Seismic Walkdown Checklist (SWC)

Equipment ID No. 1-1205-EG-002 Equip. Class¹² 21 (Tanks and Heat Exchangers)
 Equipment Description RHR HEAT EXCHANGER B
 Location: Bldg. AUX Floor El. 143'-6" Room, Area RC-91
 Manufacturer, Model, Etc. (optional but recommended) _____

Equipment ID No. 1-1205-P6-002R Equip. Class¹² 6 (Vertical Pumps)
Equipment Description RHR PUMP B

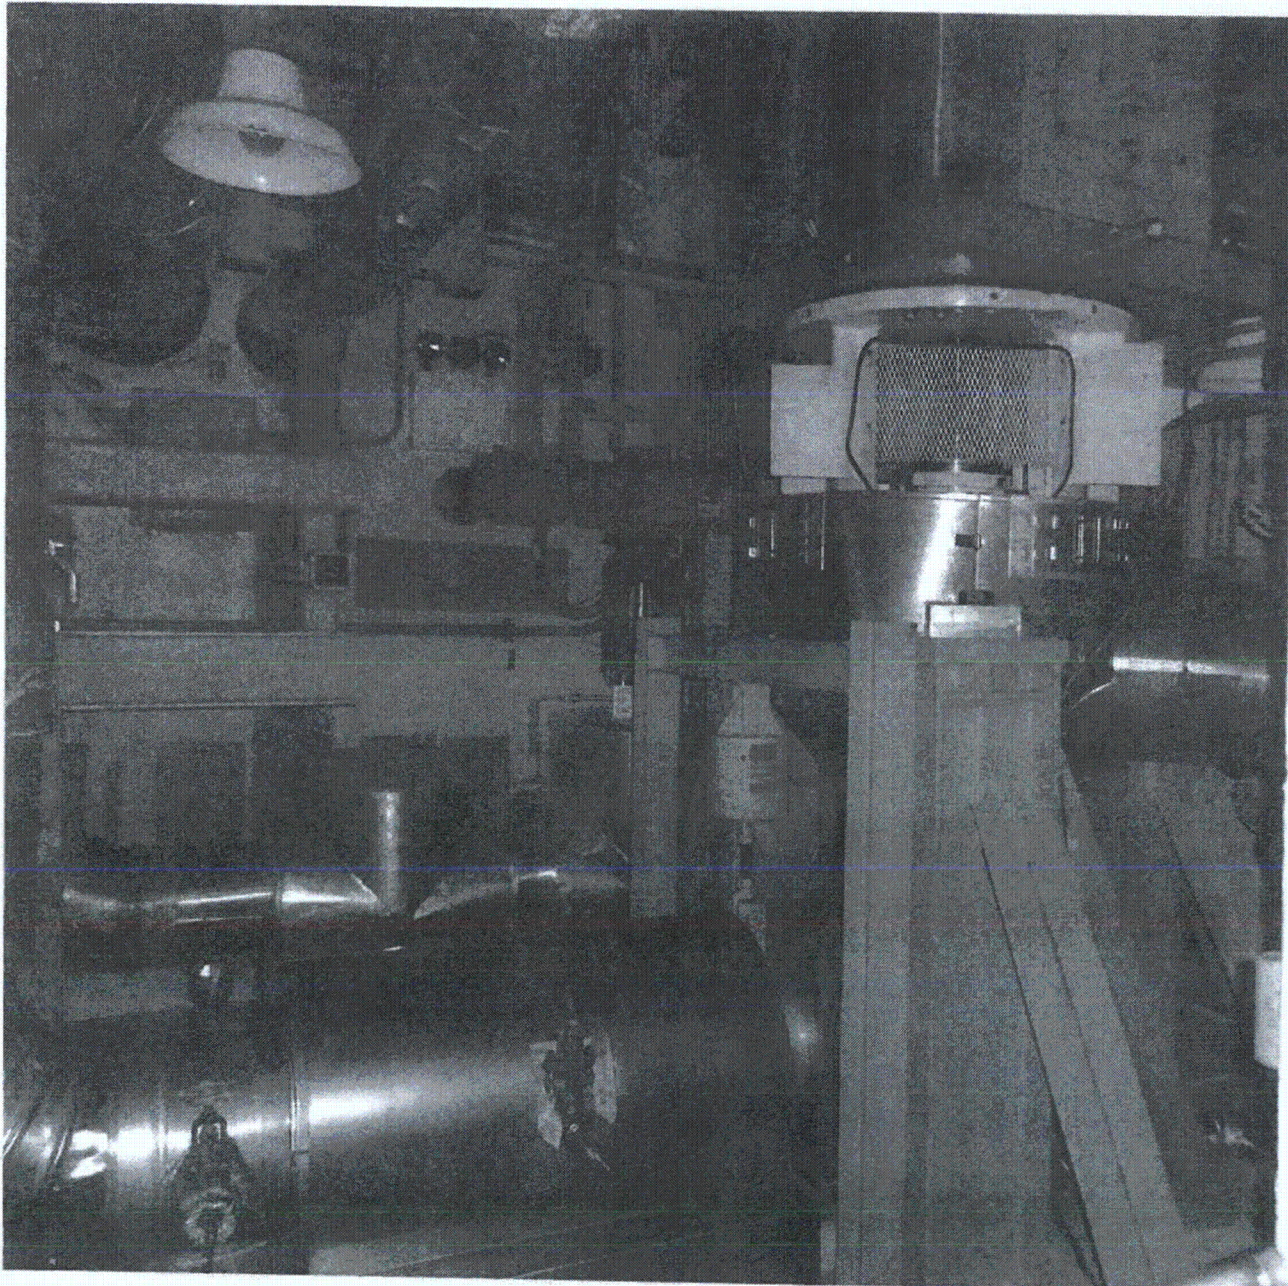
3. Is the anchorage free of corrosion that is more than mild surface oxidation? Y N U N/A
 POSSIBLE BORIC ACID ON FLOOR
 NOT A SEISMIC CONCERN
 DISCUSSED WITH BORIC ACID PROGRAM OWNER - NO ISSUE

5. Is the anchorage configuration consistent with plant documentation? Y N U N/A
 (Note: This question only applies if the item is one of the 50% for which an anchorage configuration verification is required.)
 VERIFIED BASED ON PAST INSPECTION DOCUMENTATION (IP REG)
 AND DWGS AXGA F02-2007 UBR. 4.0
 AX20.08A002 UBR. 25.0

8 bolts on mounting plate - two bolts per section. This is consistent with previous documentation.

Equipment ID No. 1-1206-P6-002 Equip. Class¹² 5 (Horizontal Pump)

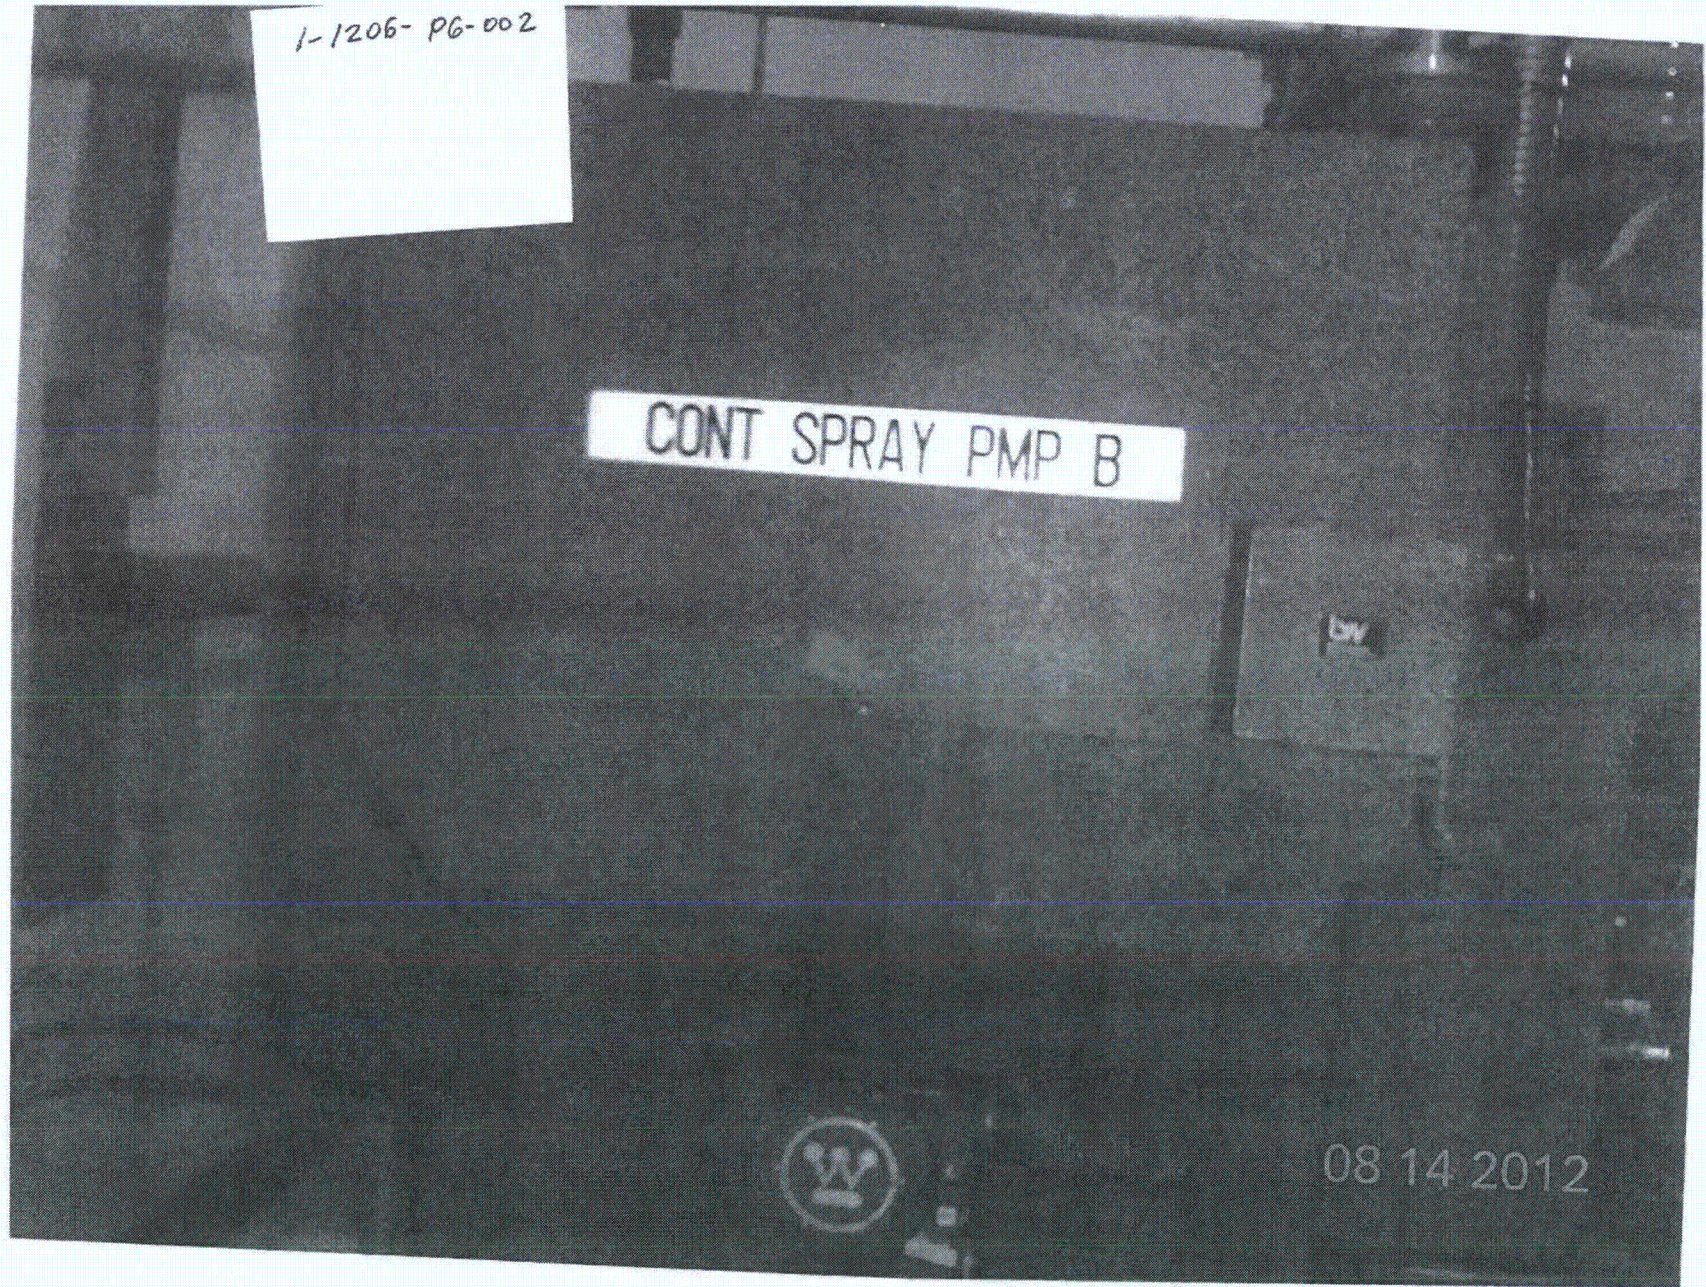
CR-501548 already written, with resolution that light fixture above equipment in room RD77 is not a seismic concern. Therefore, no additional concerns exist, and CR with resolution is acceptable.
